Models 61,268,272

New silencer SA

compl 503 59 92-05 (XPSA)
compl 503 59 92-06 (SA)

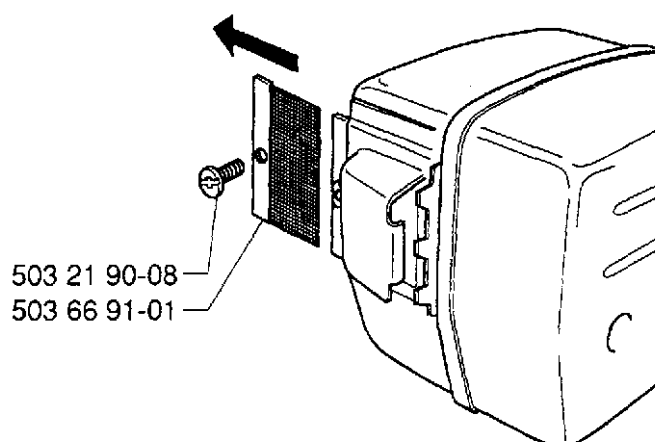
In order to improve the durability and to eliminate damage on the chain brake handguard, a new silencer with a fixed exhaust deflector is introduced. The new design also means that only the spark arrester screen can be changed.

Exhaust deflector ref. no. 503 55 32-01 and spark arrester screen ref. no. 503 40 56-01 remain as spare parts. The two spark arrester screens are not interchangeable.

NOTE! The change above is only applicable for the new design of the model 61.

New ref. no.	Description	Excluded ref. no.
503 59 92-05	Silencer compl. XP SA	{ 503 59 92-01
		{ 503 59 92-03
503 59 92-06	Silencer compl. SA	{ 503 59 92-02
		{ 503 59 92-04
503 66 91-01	Spark arrester screen

Introduced from serial number: 61-3190466
268-3151001
272-3160067
